#### FINAL DRAINAGE REPORT FOR SADDLEHORN RANCH – FILING 2

> June 4, 2021 Project No. 25142.04

El Paso County PCD File No.: SF-XX-XXX

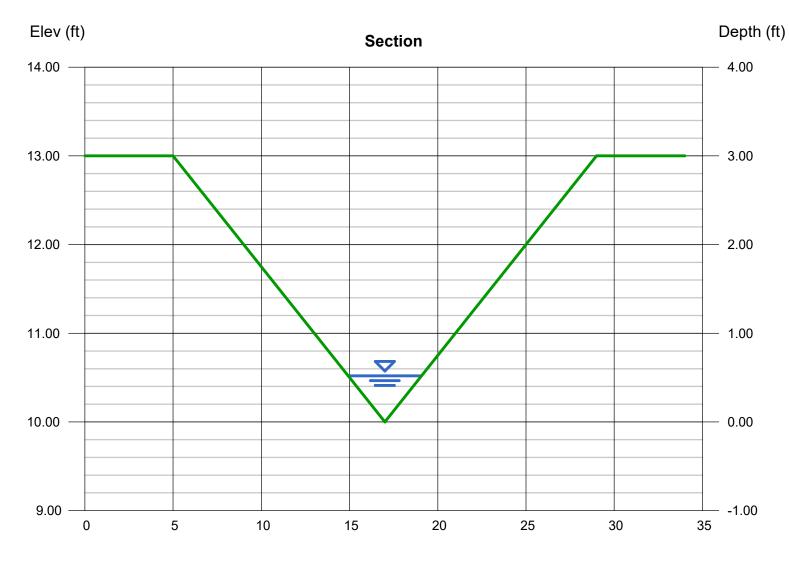
_	si	D's show 4:1 side slopes des on all swales. Please	confirm		Thursday, May 20 202
DP 1.0 Swale (5-Y		nd update based on whicl enario is to be used.	1		
Triangular			Highl	ighted	
Side Slopes (z:1)	= 4.00	), 4.00	Depth	n (ft)	= 0.52
Total Depth (ft)	= 3.00	)	Q (cfs	s)	= 1.500
			Area	(sqft)	= 1.08
Invert Elev (ft)	= 10.0	00	Veloc	ity (ft/s)	= 1.39
Slope (%)	= 0.50	)	Wette	ed Perim (ft)	= 4.29
N-Value	= 0.03	30	Crit D	epth, Yc (ft)	= 0.39
			Top V	Vidth (ft)	= 4.16
Calculations			EGL (	(ft)	= 0.55
Compute by:	Knowr	ı Q			
Known Q (cfs)	= 1.50	)			
				Include Froud	e Number

Include Froude Number and sub/super critical designation for each swale
